**FINDINGS AND RECOMMENDATION
OFFICE OF PLANNING AND ZONING
ANNE ARUNDEL COUNTY, MARYLAND**

CASE NUMBER: 2024-0109-V and 2024-0156-S

REQUEST

VARIANCE LOCATION PLAN
PELLICANO PROPERTY COTTAGE
GRADING AND VARIANCE PLAN
1714 WINCHESTER ROAD
ANNAPOLIS, MD 21409
WINCHESTER
TAX MAP: 45, GRID: 6, PARCEL: 568, ZONING: R1/RCA
TAX ACCOUNT: 03-000-28318055
THIRD ELECTION DISTRICT ANNE ARUNDEL COUNTY, MARYLAND
DATE: OCTOBER 2024
SCALE: AS SHOWN SHEET 1 OF 3

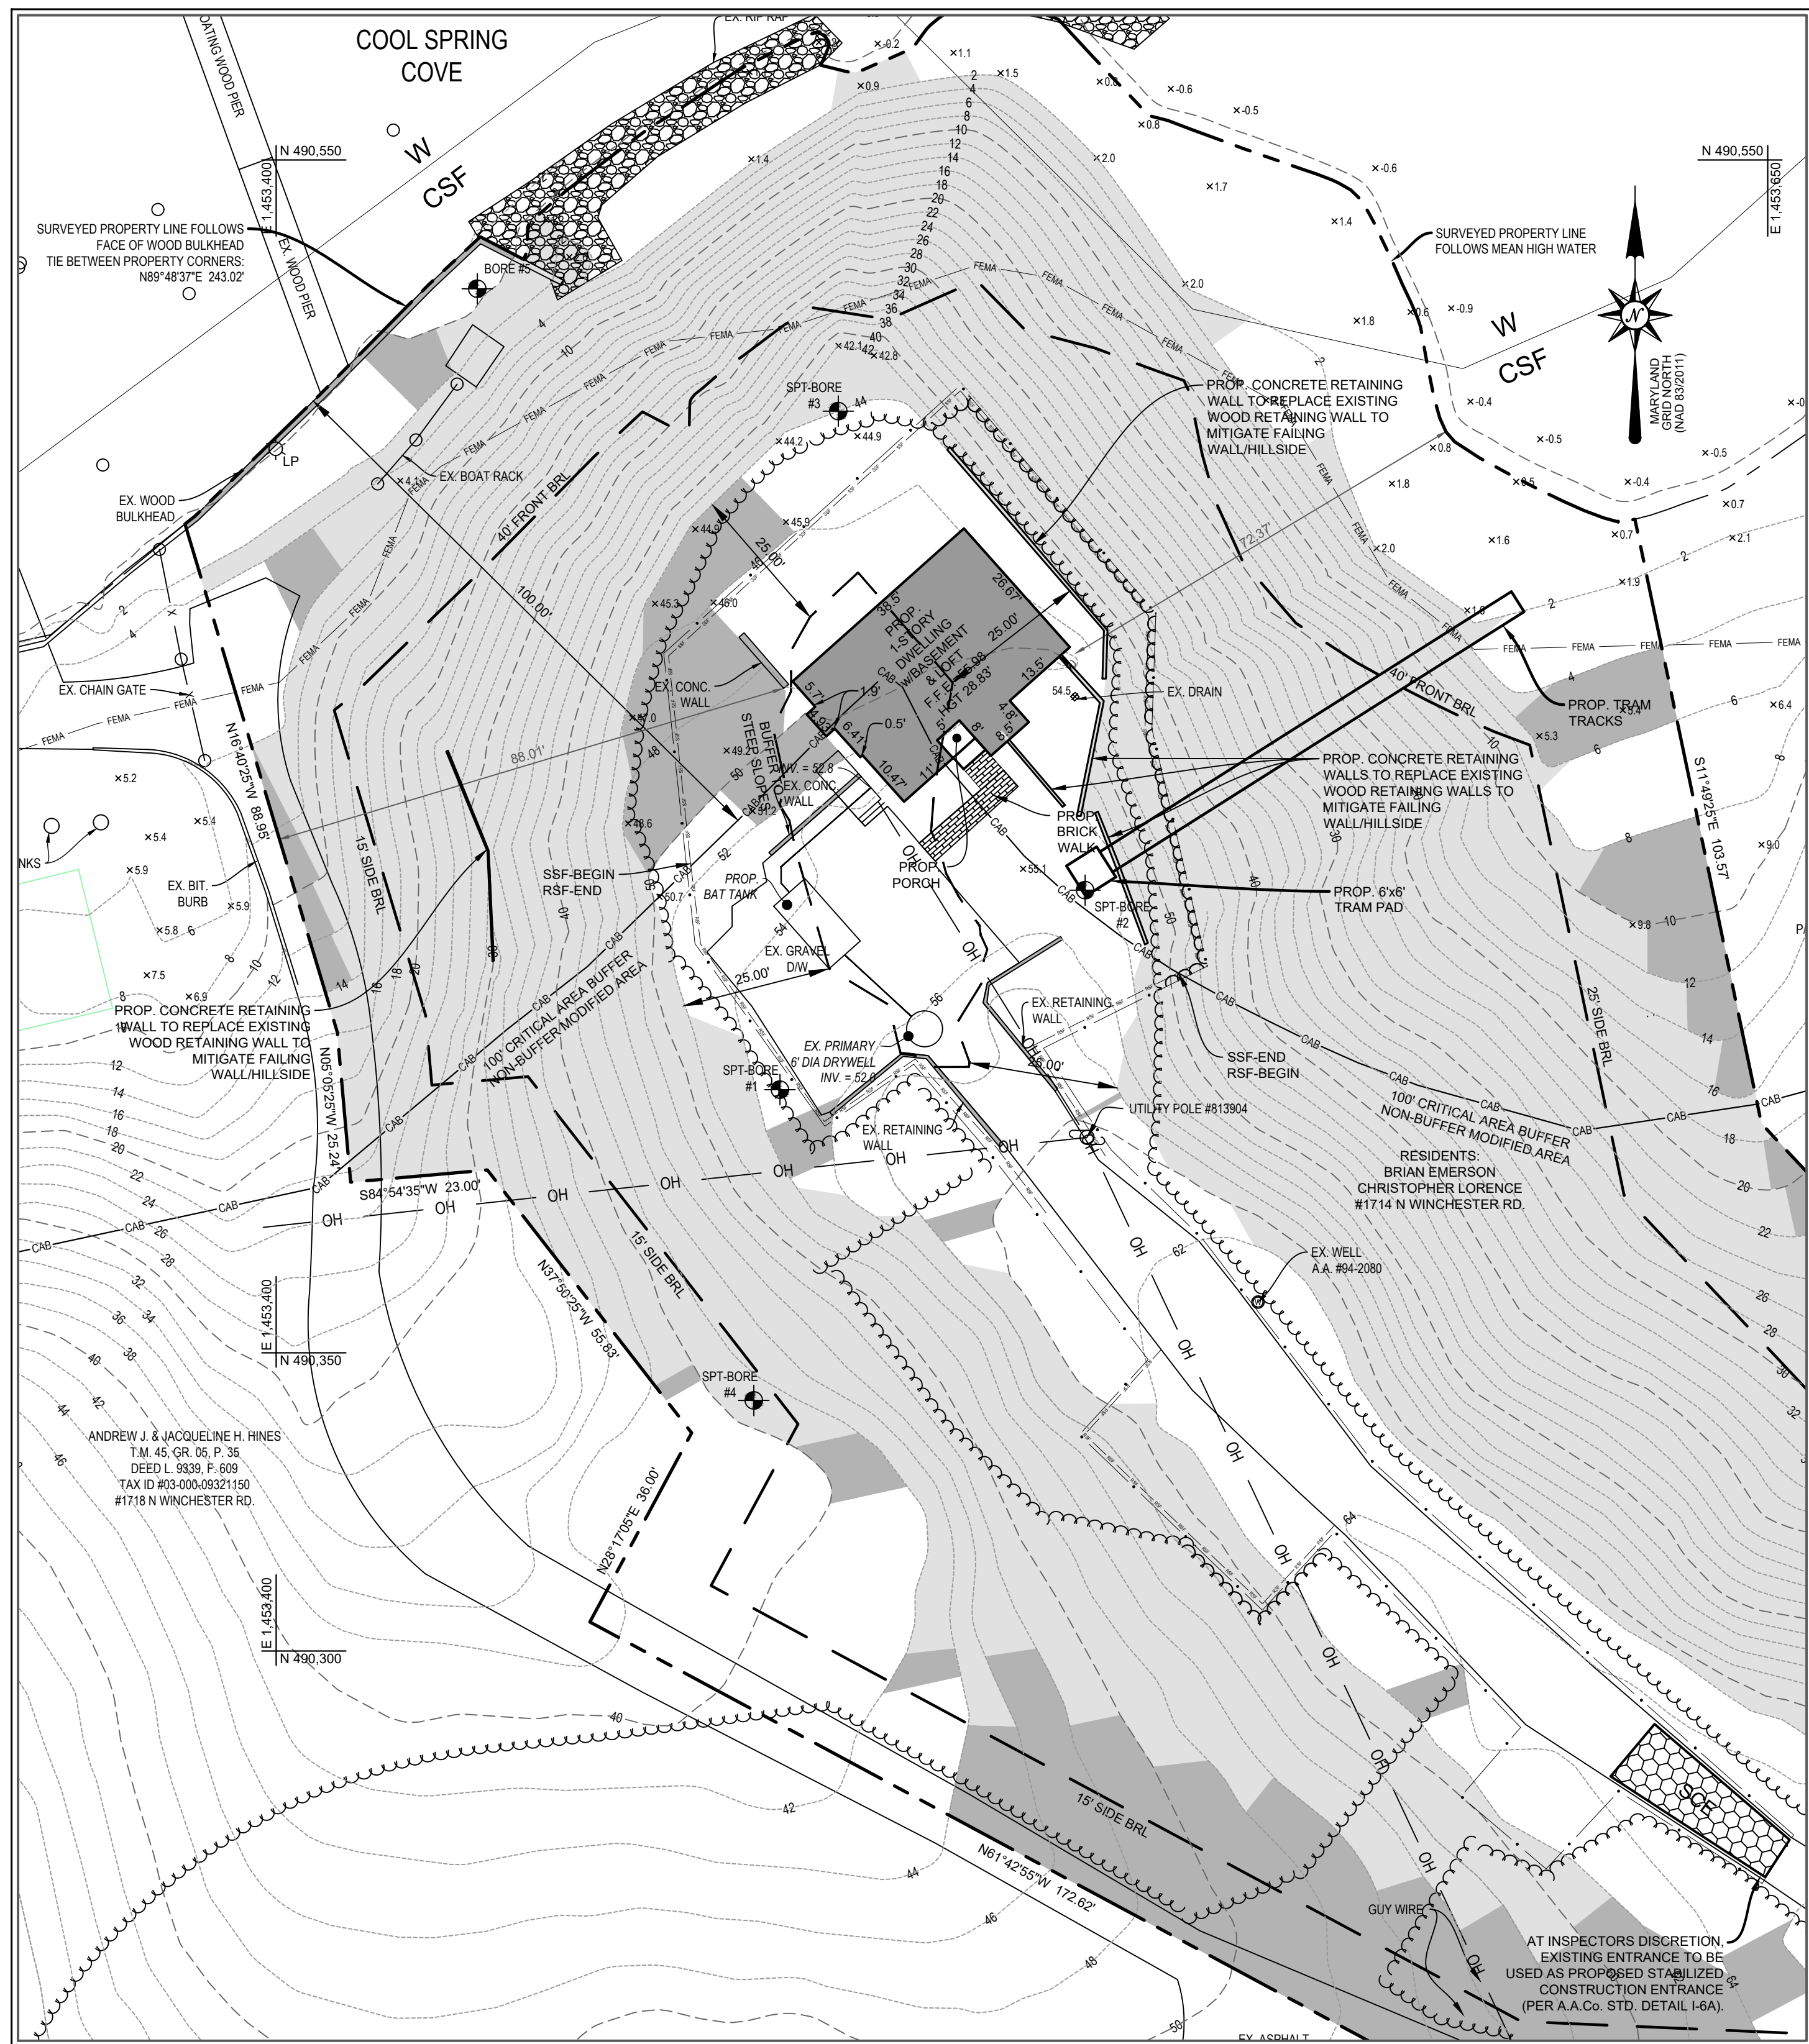
However, the applicants are also proposing to replace several of the existing retaining walls to the east of the cottage, which will include the removal of approximately 1,383 square feet of woodland. While removing some of the tree canopy to replace those walls may be unavoidable, it appears that the walls could be combined/redesigned into a single wall which may save the 28" caliber tree. Additionally, a retaining wall to the far west of the cottage is noted to be replaced but is not within the limits of disturbance, nor is any change in the tree canopy shown. No justification had been provided to explain that the tree removal could not be minimized.

With regard to the shed replacement, the applicants are proposing to replace two sheds (12.5' x 24.5' and 8.5' x 12') with one larger shed (13.5' x 32.5') in an area of steep slopes. While the new shed is proposed in the same location as the larger of the two existing sheds, its footprint is larger and will therefore disturb more of the steep slopes in that location. The location of the smaller existing shed appears to have a level area which would accommodate the proposed shed, but the applicants offered no explanation as to why one location was chosen over the other.

The site plan does not correctly depict the required expansion of the Critical Area buffer.

DRAINAGE AREAS TO ESD FACILITIES
SCALE: 1" = 20'

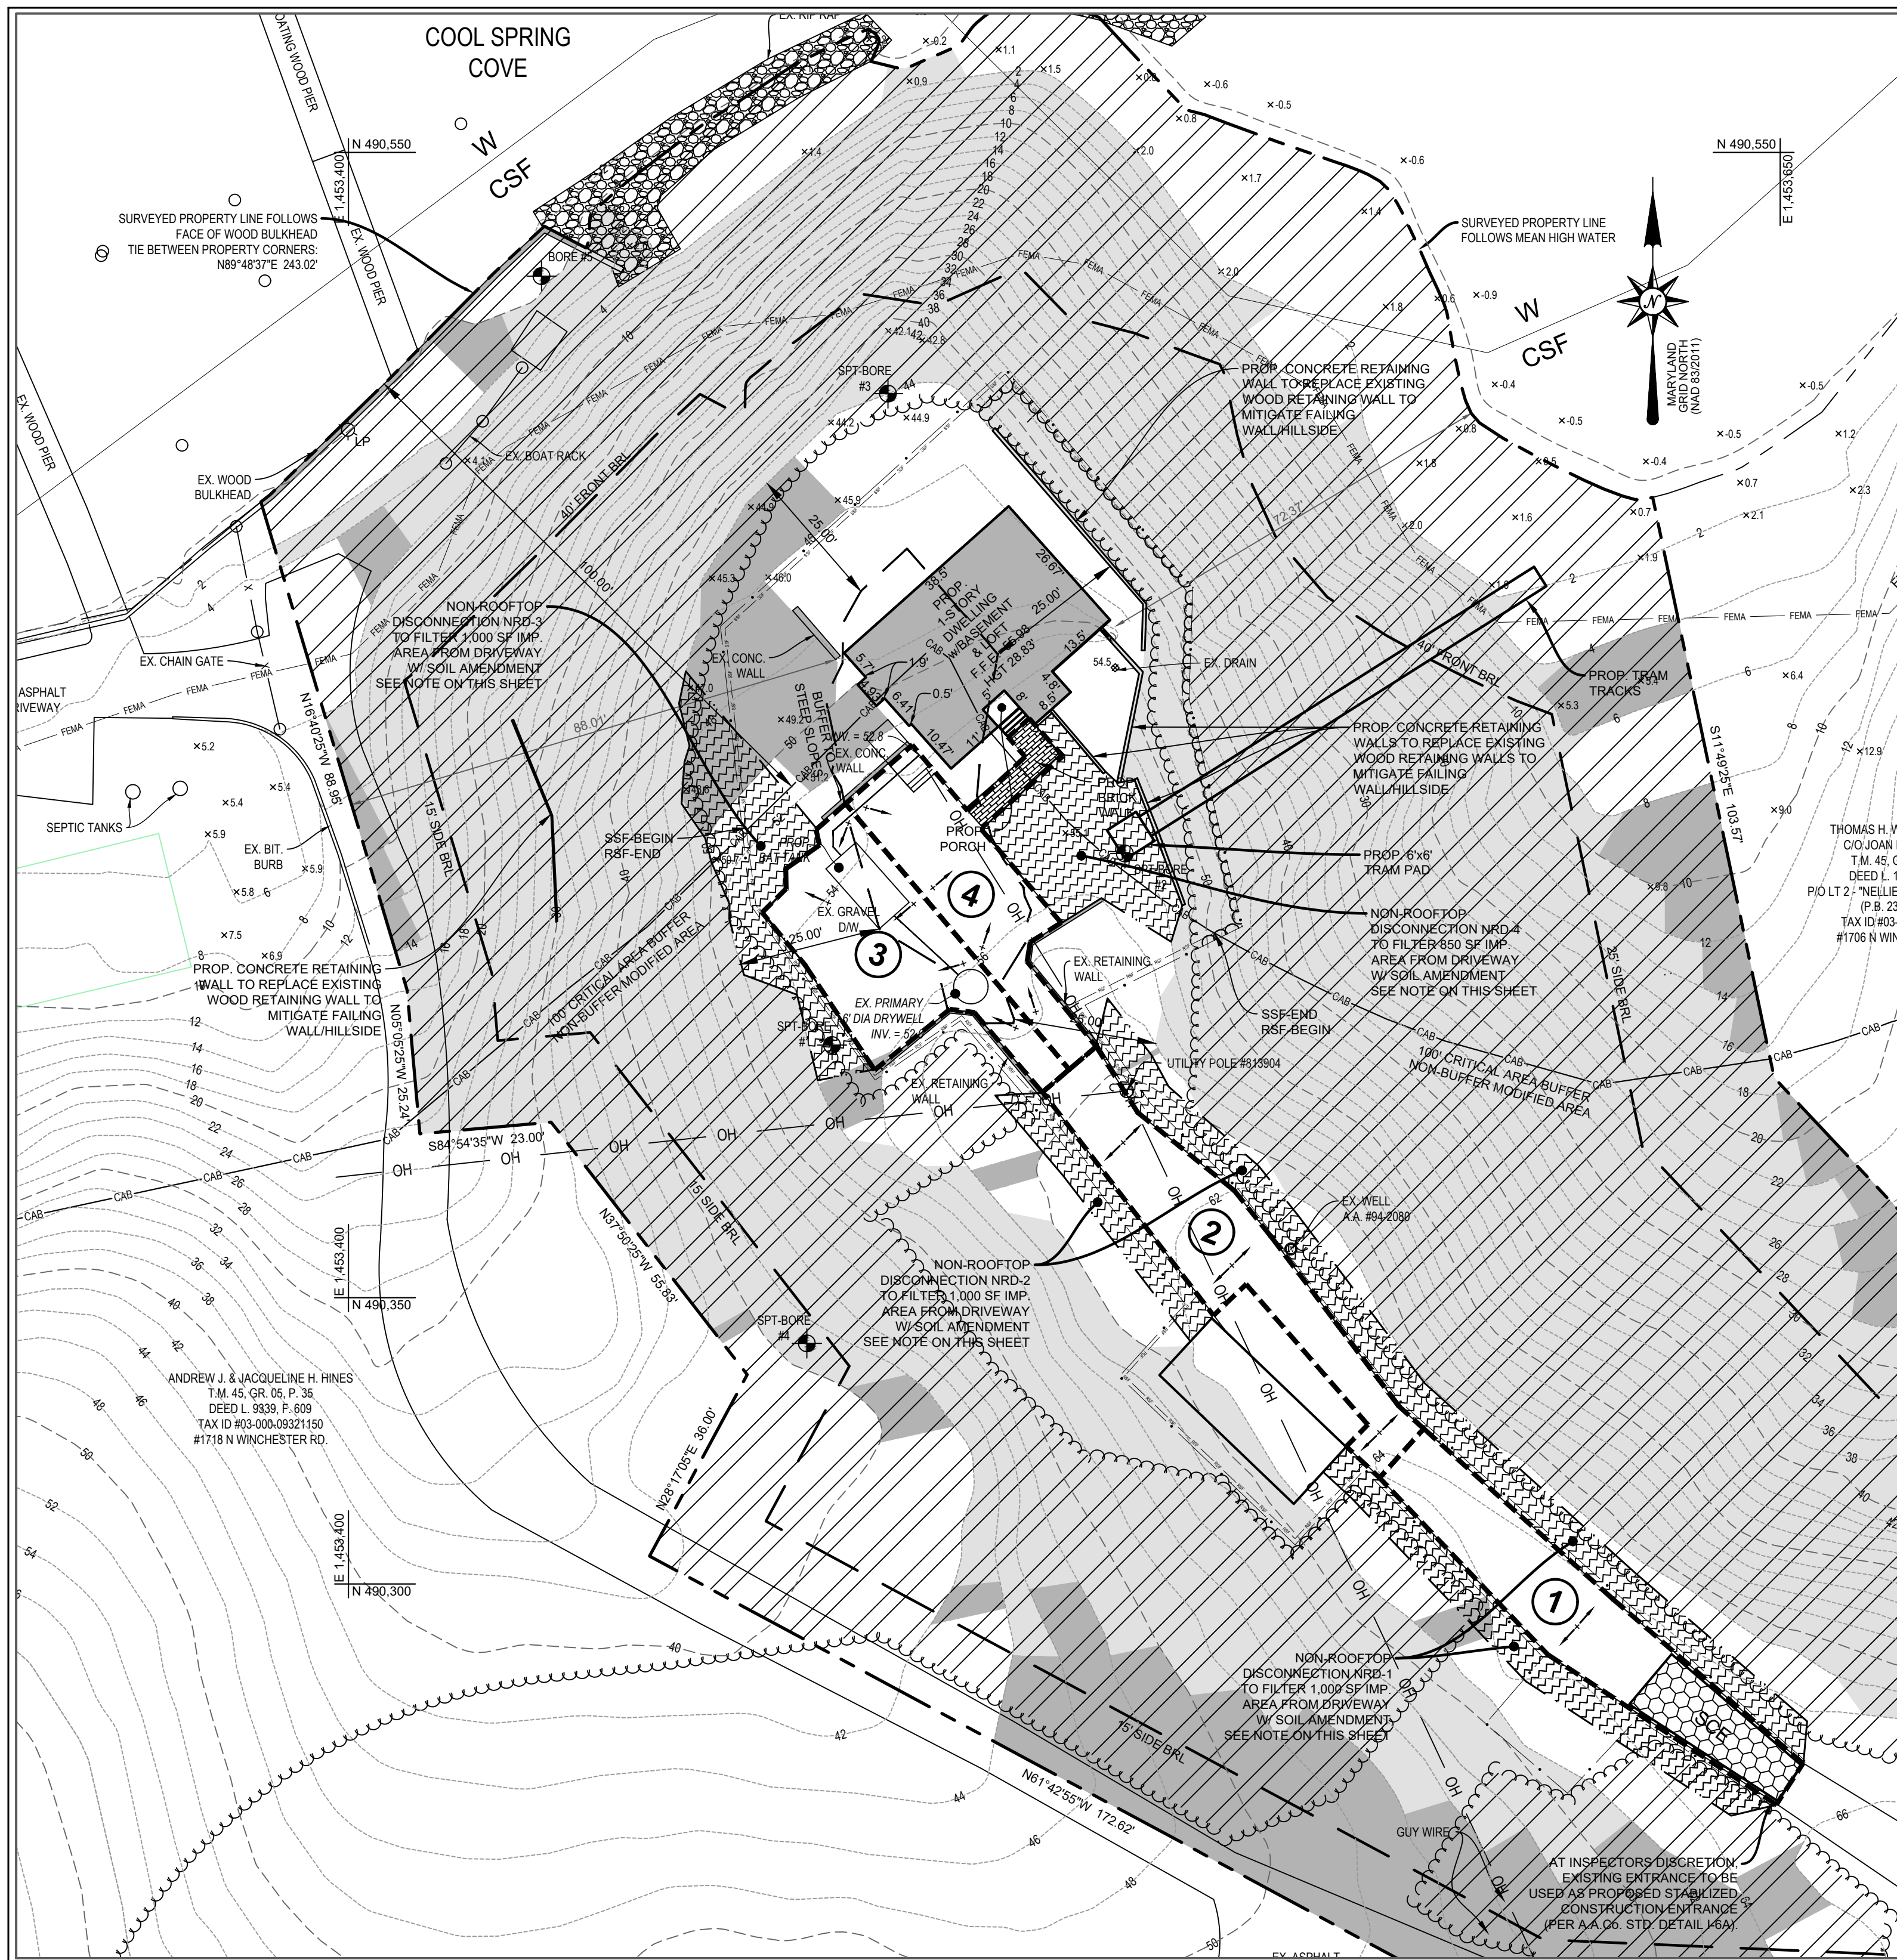
4. A soil boring is required per practice. The suitability, and siting of proposed SWM practices should be reviewed. Soil boring information including verification of the suitability of in-situ soils for infiltration shall be submitted. Describe the site's hydrologic, and topographic characteristics and provide recommendations on the feasibility of various BMPs.
